Old Mill Road, Okiwi Bay Resource Consent U071253
Request for further information

Title:
SITE PLAN
Barry Large
Lot 17 DP 19155
Okiwi Bay

Request for Further Information - U071253 - Large, Barrie & Jane - Old Mill Road Okiwi Bay

ENGINEERING REPORT

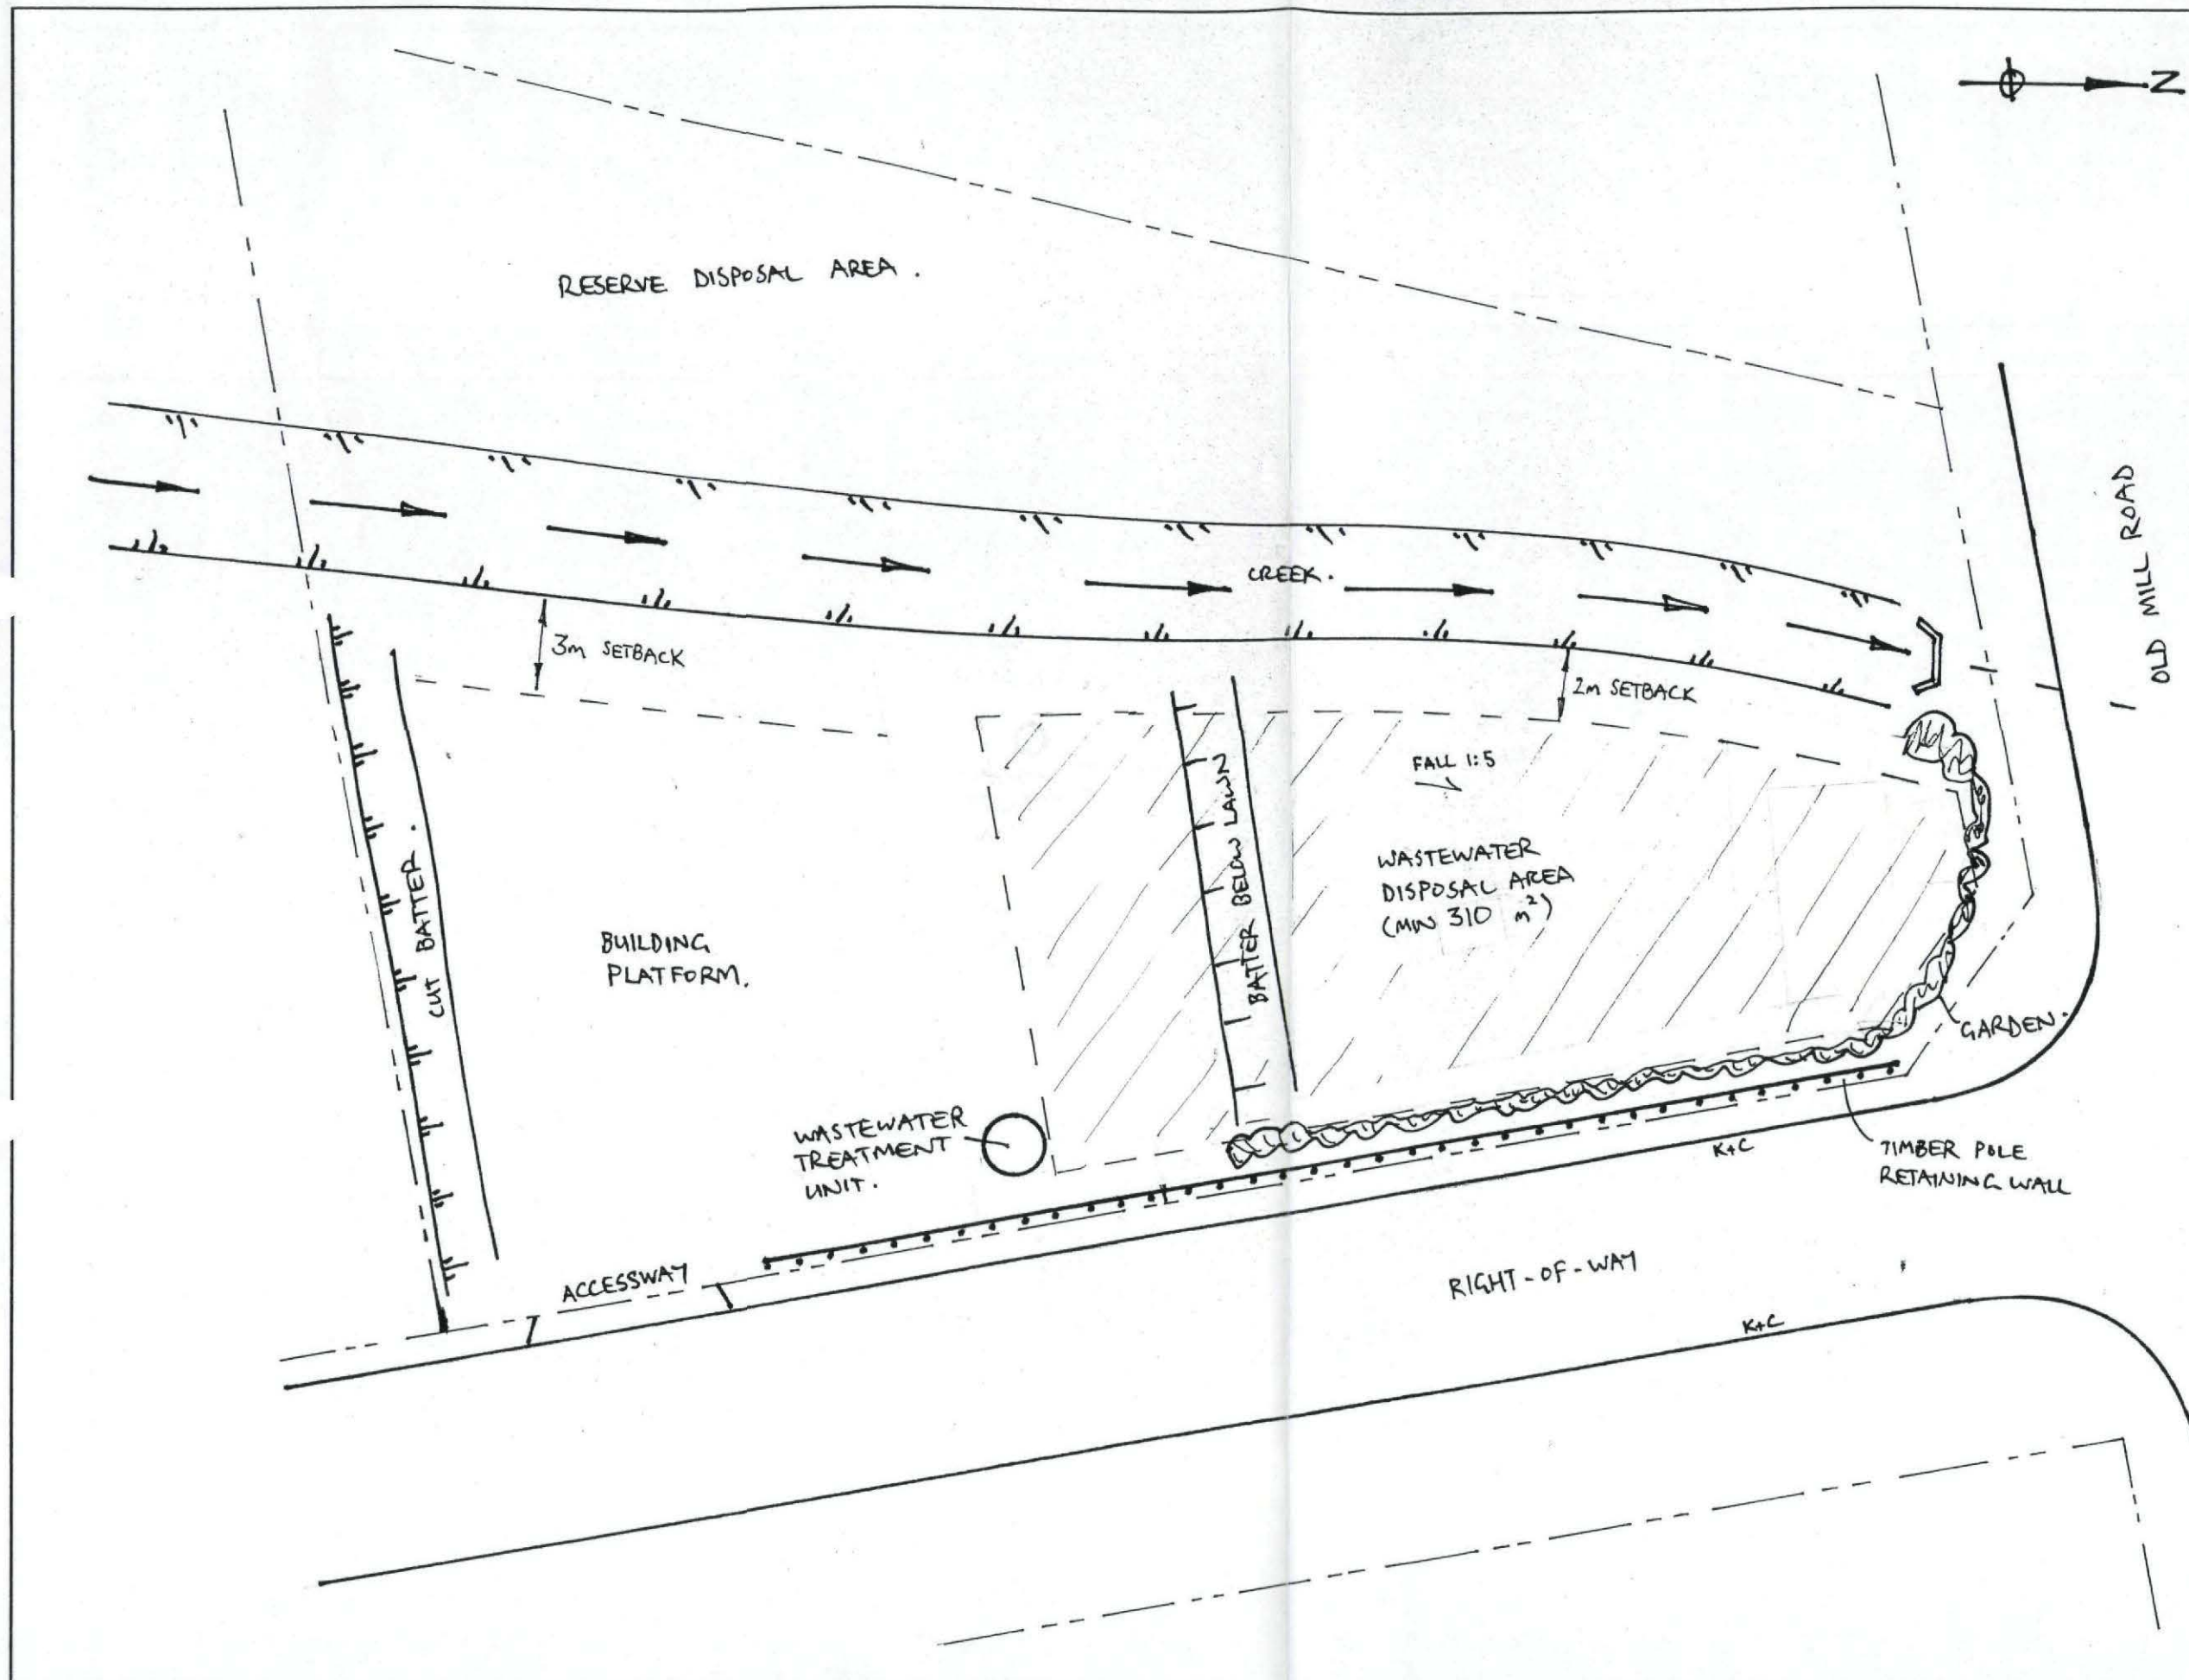
1. The volume of wastewater has been calculated on a four bedroom (8 person) household and does not include an additional 2 people that could be accommodated in a rumpus room. The additional loading should be factored into the design for the wastewater management system. Please provide an amended design to reflect this.
2. A Land Use consent will be required for the excavations on the site exceeding 20m³. I note that Mr Swanney refers to a 2m high cut and batter in his Geotechnical Assessment. Please provide a Geotech opinion to cover all excavation works to support the application.

1. Increasing the loading on the wastewater system from 8 to 10 persons increases the required application area to a minimum of 307m² ($10/8 \times 246\text{m}^2 = 307\text{m}^2$). The application area on the Site Plan has been altered to show this increase. The area has been increased further to the north and south of the original area.
